MPC Paper No. 12/16

**For Consideration by
the Metro Planning Committee on 26.8.2016**

**FURTHER CONSIDERATION OF THE
DRAFT PLANNING BRIEF FOR THE
“COMPREHENSIVE DEVELOPMENT AREA(1)” ZONE
IN KAI TAK DEVELOPMENT**

零售地帶柱廊概念圖
COLONNADE CONCEPT DRAWING FOR RETAIL BELT

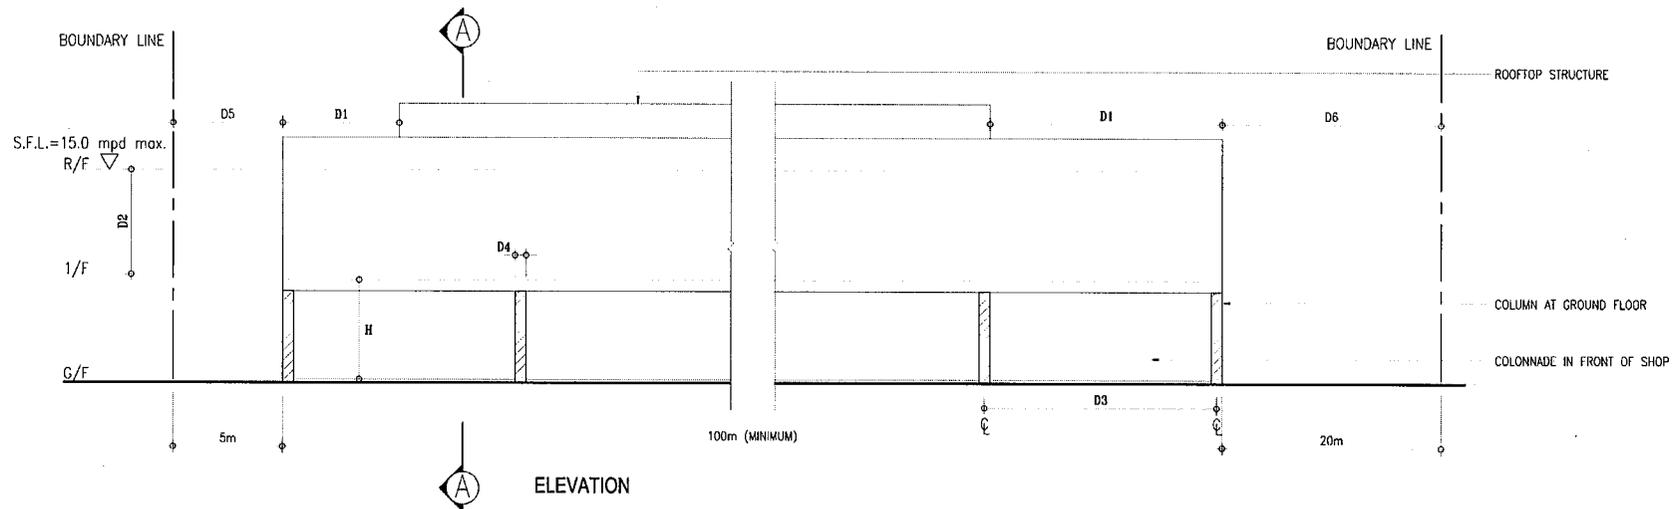
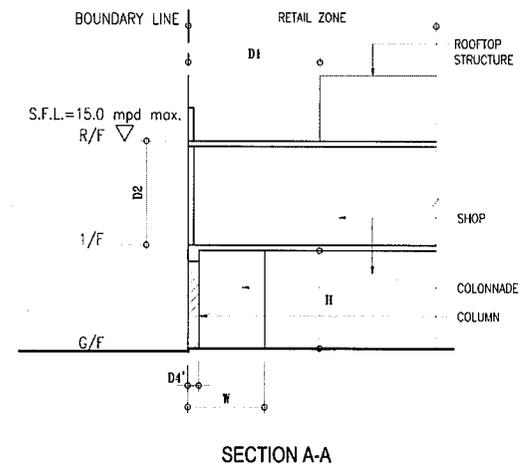
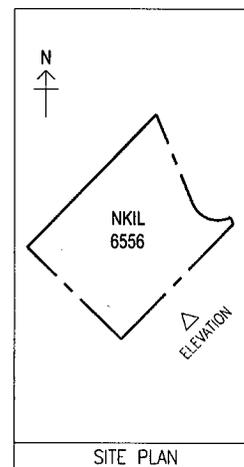
- (c) Despite its design merits, the colonnade design may take up a lot of floor space, resulting in a waste of scarce land resources, and attract wanderers, leading to management issue. The G/F passageway under the colonnade should be designated for public use to avoid abuse by developer for commercial use, and such area should be utilized for other effective uses such as social welfare facilities.
- (d) The incorporation of detailed design requirement in the land sale conditions may affect the design flexibility of the proposed development.

- 4.5 The retail belt with colonnade design has only a width of about 15m, and the G/F passageway under the colonnade is about 3.6m wide. It is of reasonable scale without taking up substantial floor area. It would enhance the vibrancy and walking experience of the pedestrians along the Station Square, protect the pedestrians from sun, rain and adverse weather, and bring back the old Kowloon atmosphere.

- 4.6 While basic design parameters like the width, depth and headroom of the G/F passageway will be set out in the lease conditions to ensure design consistency among different sections of the retail belt, there is still flexibility for the future developer to come up with their own design within the broad framework set out in the OZP and lease.

- 4.7 The future developer of the Site will be responsible for managing and maintaining the colonnade. To avoid abuse, it will be set out in the lease conditions that the G/F passageway under the colonnade is dedicated for public use, and any non-compliance will be subject to enforcement action under lease.
